Environmental Re-evaluation

ENVIRONMENTAL
IMPACT STATEMENT

Subject: Mountain View Corridor, Salt Lake County and Utah County Final Environmental Impact Statement and Final Section 4(f) Evaluation dated September 2008; Record of Decision dated November 17, 2008

Re: Mountain View Corridor Environmental Re-evaluation #2
UDOT Project Number *SP-0067(3)0

Figure A-09

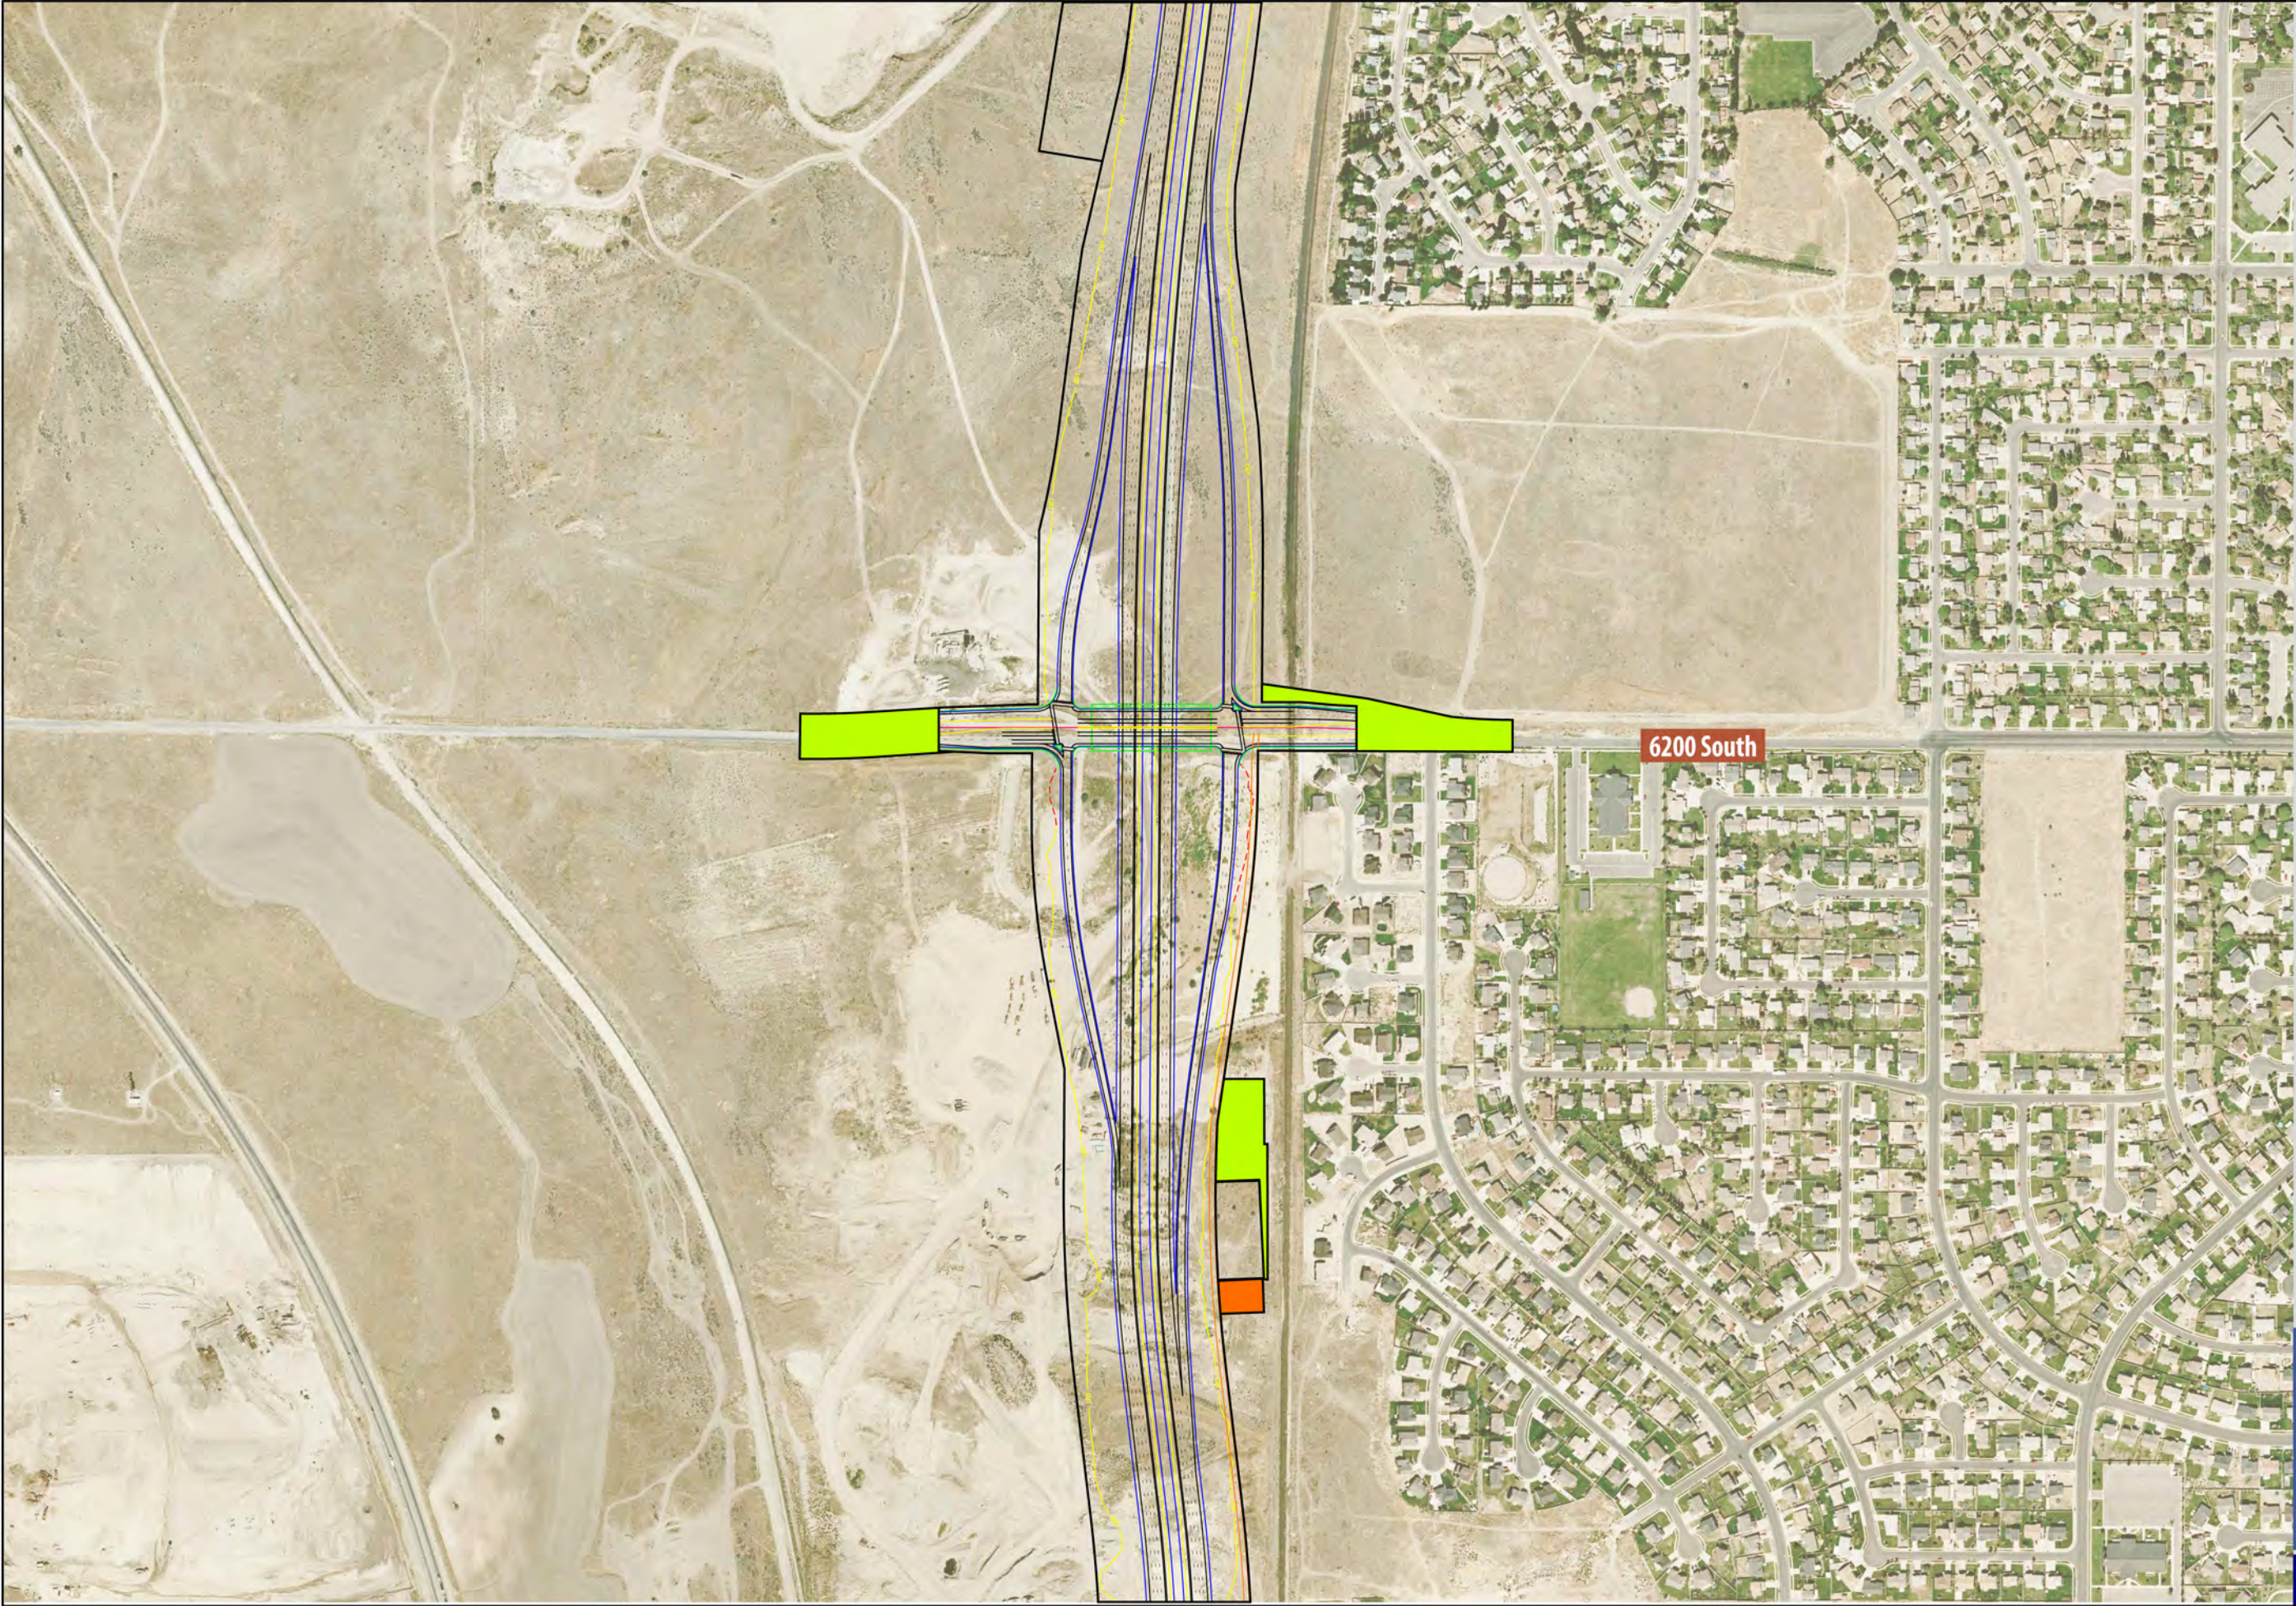
- 7800 South
 - To provide a connection at the 7800 South–MVC intersection, the four traffic lanes with turn lanes analyzed in the Final EIS would need to be extended an additional 775 feet on the east side and 800 feet on the west side of the MVC (see Appendix A, Figure A-09).
